Our Case Number: ABP-322329-25

Re: Ballina Flood Relief Scheme - River Moy

Submission in opposition to the proposed work of the *Ballina Flood Relief Scheme (BFRS)* within and around the Moyvale Estate, on Sligo Road in Ballina. Specifically the Bunree (Behy Road) Stream. Copy of planning notice included as Fig 1. Below. <u>An Bord Pleanála Case Number: ABP-322329-25</u>

Key to locations on map.

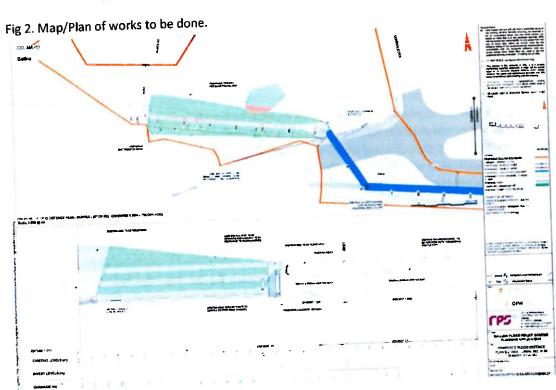
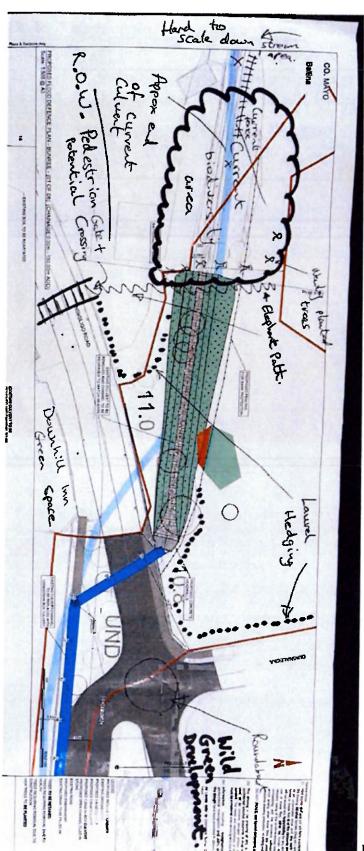
- 5. Another point made by some residents is that there are a lot of established trees along the course of the current stream and particularly the culverted area of Moyvale. There are far more than are highlighted on the map provided to us (Fig 2 below). At the moment these provide a sound barrier from the very busy N59 at night when boy racers are terrorising the area with noise pollution. They also provide privacy for us as residents from the National road and the backs of the houses that face the N59 (also near 11 and 12 Moyvale Park). If these trees are removed to facilitate the opening up of the culvert and creating new banking we would lose all of those protections. On the point of boy racers we feel the planned digging up of the N59 to increase the width of the pipes would provide an ideal opportunity to include a raised pedestrian crossing from the pedestrian gate of Moyvale to over to The Downhill Inn and Knocknalyre. A potential crossing would serve 3 important functions...

Photo A: Deep Sided Stream Centre surrounded by brambles.

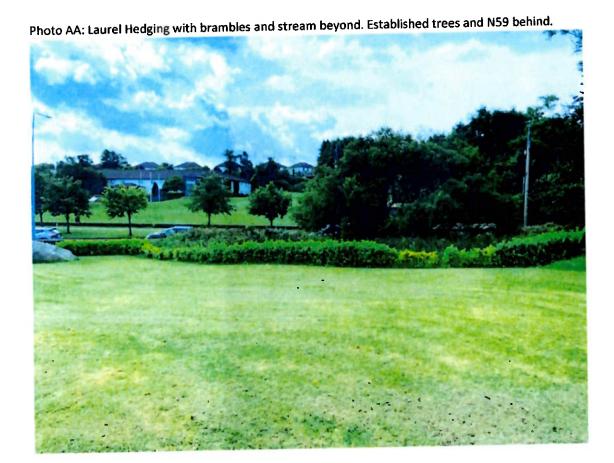
- Now to read that it is to be opened up even more feels like a slap in the face of these requests. In March 2020 a young child was tragically drowned in a stream in the Rehins Fort Estate, also in Ballina, and we feel that <u>any</u> open water source presents too much of a risk next to where our children play. In 2022 a Moyvale child had a close call when going down there to retrieve a scooter that had been taken and thrown down there by a teenager from outside of our estate. If an adult hadn't been present the outcome could have been different and the only deterrent from this happening again is a high gathering of unsightly brambles that we cannot remove until the current <u>short</u> section of stream is culverted.
